SUBJECT: ISSUANCE OF AMENDMENT NOS. 60 AND 40 TO FACILITY OPERATING LICENSES NPF-11 AND NO. NPF-18 - LASALLE COUNTY STATION, UNITS 1 AND 2 (TAC NOS. 67958 AND 67959)

The amendments revise the LaSalle County Station, Units 1 and 2 Technical Specifications by providing additional requirements for monitoring core performance and other actions to be taken by the reactor operator in the high power/low flow region of the power to flow map.

Amendment No. 60
License No. NPF-11

Amendment No. 40
License No. NPF-18

Figure 3.4.1.5-1

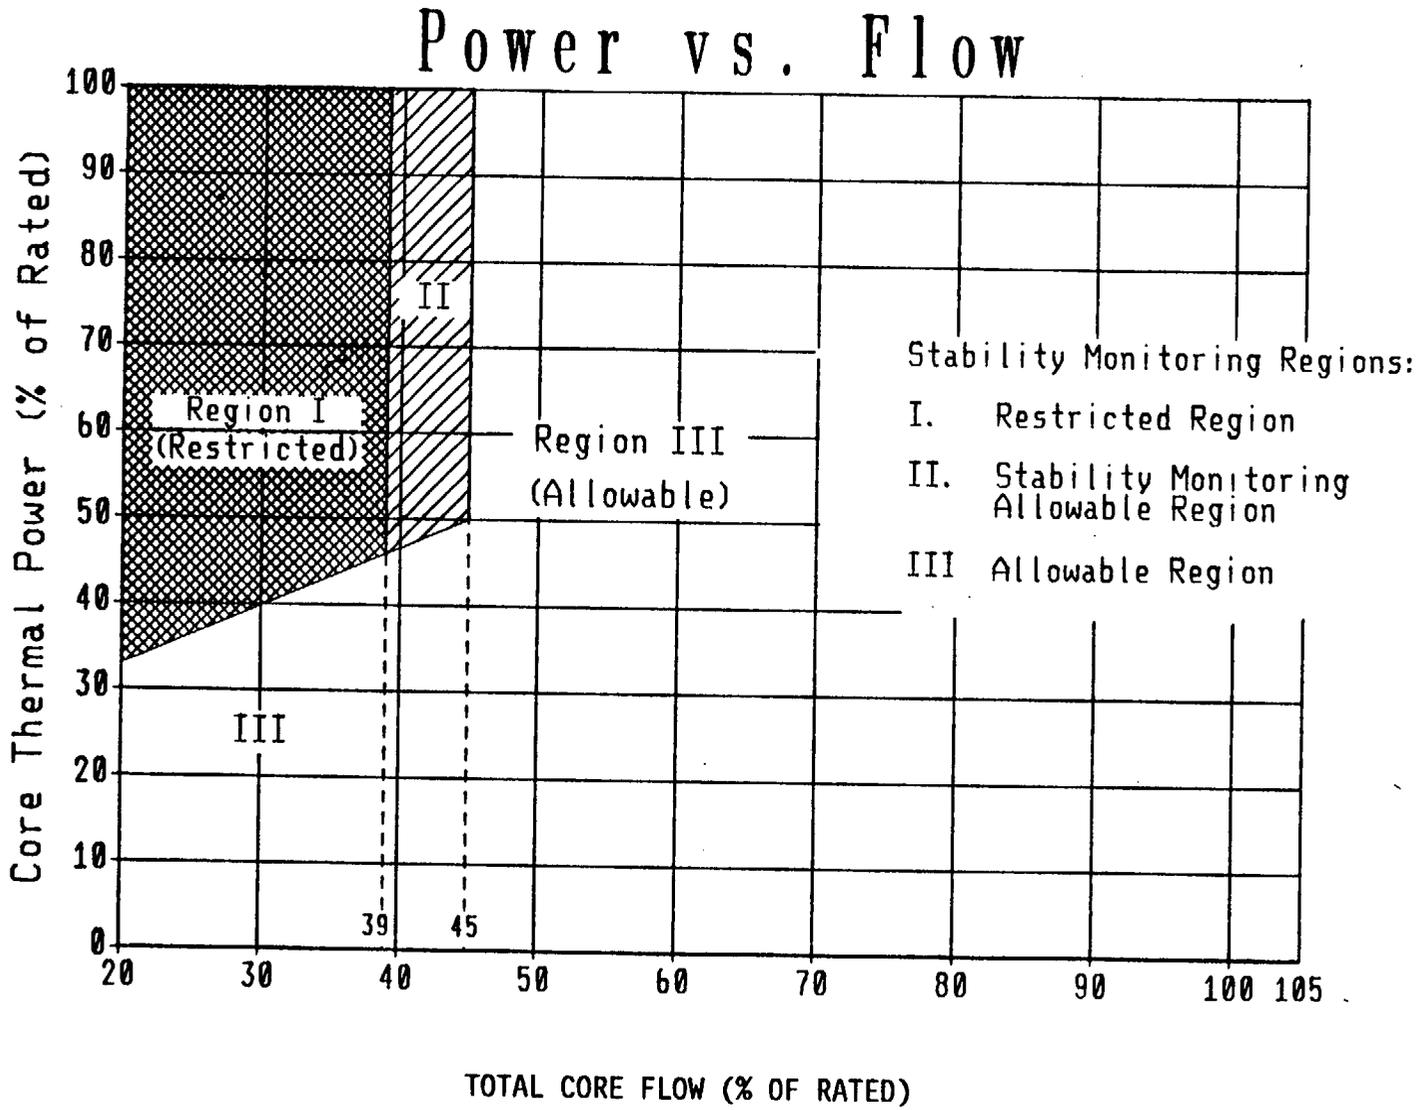
- a. Total core flow greater than or equal to 45% of rated core flow, or
- b. THERMAL POWER within Region III of Figure 3.4.1.5-1, or
- c. THERMAL POWER within Region II of Figure 3.4.1.5-1 AND APRM and LPRM noise levels not exceeding the larger of: i) Three (3) times the established baseline noise levels or, ii) 10% peak-to-peak indicated noise level.

- a. In Region I of Figure 3.4.1.5-1:
 1. With at least 1 reactor coolant recirculation loop in operation immediately initiate action to:
 - a) Decrease THERMAL POWER by control rod insertion, completing the power decrease within two (2) hours to exit Region I or,
 - b) Increase core flow with the operating Recirculation Loop(s), to exit Region I within two (2) hours.
 2. With no reactor coolant recirculation loops in operation:
 - a) Immediately reduce CORE THERMAL POWER by inserting control rods, observing the indicated APRM and LPRM noise levels, and complete power reduction to below 36% of RATED CORE THERMAL POWER within two (2) hours, and
 - b) If indicated LPRM or APRM noise levels exceed 10% peak-to-peak, immediately place the reactor mode switch in the SHUTDOWN position.
 - c) Comply with Specification 3.4.1.1 ACTION b.2

- b. In Region II of Figure 3.4.1.5-1, with APRM or LPRM neutron flux noise levels exceeding the larger of: i) Three (3) times the established baseline noise levels, or ii) 10% peak-to-peak noise indication.
 1. Immediately initiate corrective action by inserting control rods or increasing core flow to restore the noise levels to within the required limit within 2 hours, otherwise.
 2. Insert control rods to reduce THERMAL POWER and/or increase core flow to enter Region III of Figure 3.4.1.5-1 within the next 2 hours.

4.4.1.5 When operating within Region II of Figure 3.4.1.5-1, verify:

Region I of Figure 3.4.1.5-1 represents a region of the power/flow map where instability in neutron flux have been observed. Operation in this region is prohibited to ensure that stable reactor conditions are maintained. Actions to immediately exit Region I are intended to prevent lower priority (i.e., non-emergency) concerns from delaying exit from the region. Observation of neutron flux indications, while not requiring formal surveillance, is needed to avoid reliance on automatic protective systems. A manual reactor scram is required if instabilities are evidenced in Region I with no recirculation pumps operating.

Operation within a designated surveillance region (Region II of Figure 3.4.1.5-1) requires monitoring of APRM and LPRM noise levels. Observed instabilities require immediate corrective action due to the potential for increasing oscillations.

Figure 3.4.1.5-1

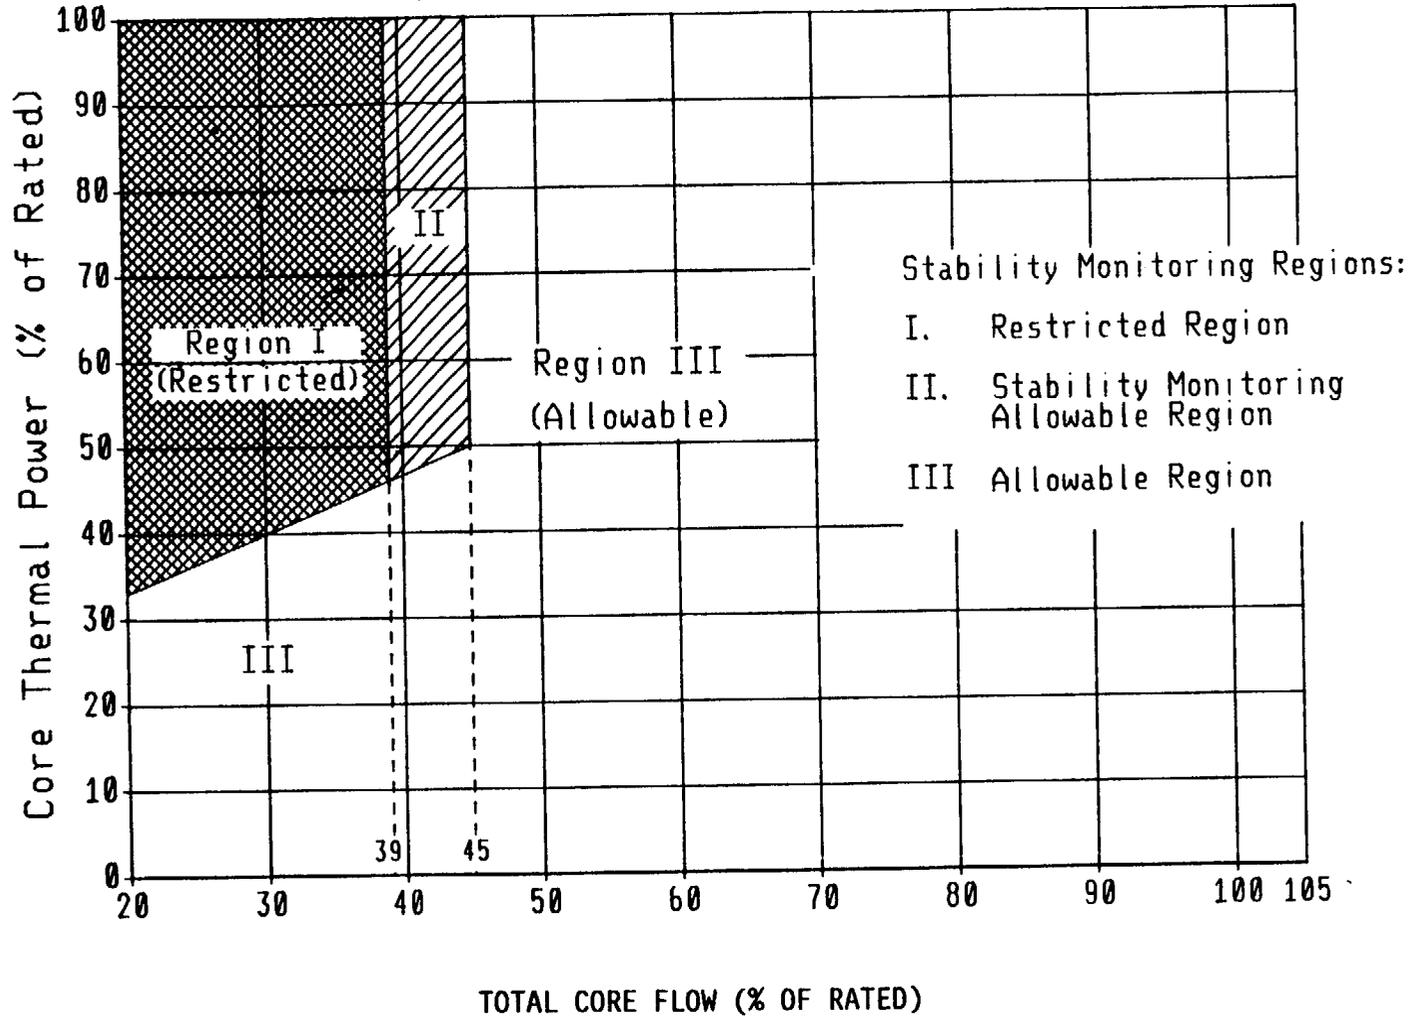
- a. Total core flow greater than or equal to 45% of rated core flow, or
- b. THERMAL POWER within Region III of Figure 3.4.1.5-1, or
- c. THERMAL POWER within Region II of Figure 3.4.1.5-1 AND APRM and LPRM noise levels not exceeding the larger of: i) Three (3) times the established baseline noise levels or, ii) 10% peak-to-peak indicated noise level.

- a. In Region I of Figure 3.4.1.5-1:
 1. With at least 1 reactor coolant recirculation loop in operation immediately initiate action to:
 - a) Decrease THERMAL POWER by control rod insertion, completing the power decrease within two (2) hours to exit Region I or,
 - b) Increase core flow with the operating Recirculation Loop(s), to exit Region I within two (2) hours.
 2. With no reactor coolant recirculation loops in operation:
 - a) Immediately reduce CORE THERMAL POWER by inserting control rods, observing the indicated APRM and LPRM noise levels, and complete power reduction to below 36% of RATED CORE THERMAL POWER within two (2) hours, and
 - b) If indicated LPRM or APRM noise levels exceed 10% peak-to-peak, immediately place the reactor mode switch in the SHUTDOWN position.
 - c) Comply with Specification 3.4.1.1 ACTION b.2

- b. In Region II of Figure 3.4.1.5-1, with APRM or LPRM neutron flux noise levels exceeding the larger of: i) Three (3) times the established baseline noise levels, or ii) 10% peak-to-peak noise indication.
 1. Immediately initiate corrective action by inserting control rods or increasing core flow to restore the noise levels to within the required limit within 2 hours, otherwise.
 2. Insert control rods to reduce THERMAL POWER and/or increase core flow to enter Region III of Figure 3.4.1.5-1 within the next 2 hours.

4.4.1.5 When operating within Region II of Figure 3.4.1.5-1, verify:

Region I of Figure 3.4.1.5-1 represents a region of the power/flow map where instability in neutron flux have been observed. Operation in this region is prohibited to ensure that stable reactor conditions are maintained. Actions to immediately exit Region I are intended to prevent lower priority (i.e., non-emergency) concerns from delaying exit from the region. Observation of neutron flux indications, while not requiring formal surveillance, is needed to avoid reliance on automatic protective systems. A manual reactor scram is required if instabilities are evidenced in Region I with no recirculation pumps operating.

Operation within a designated surveillance region (Region II of Figure 3.4.1.5-1) requires monitoring of APRM and LPRM noise levels. Observed instabilities require immediate corrective action due to the potential for increasing oscillations.
